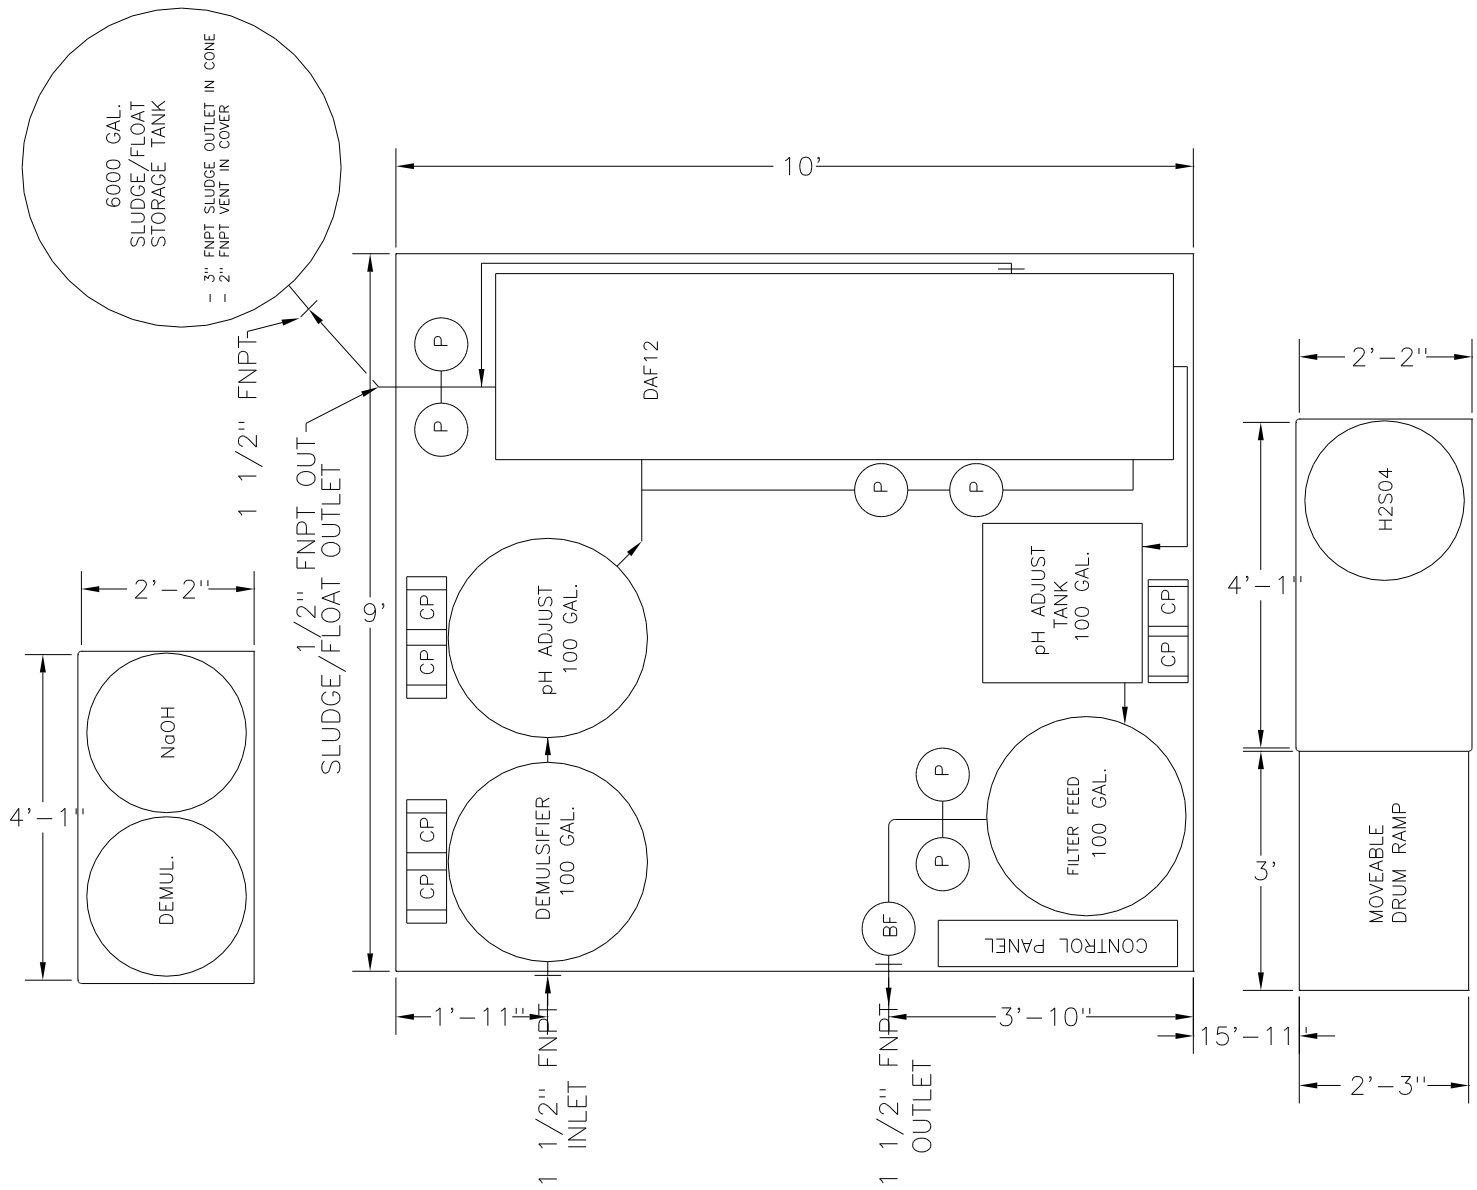
Make the skid mounted unit no wider than 8' such that it can be shipped without a wide load designation.

Switch the order of the demulsifier/pH adjustment and the pH final Adjustment/Filter feed on skid.

Add raw influent feed pumps to skid.

Show piping to 6,000 gallon tank and eliminate portions related to previously designated 500 gallon tank.

Note: 6,000 gallon tank not to scale. 7,000 gallon tank berm is to scale.
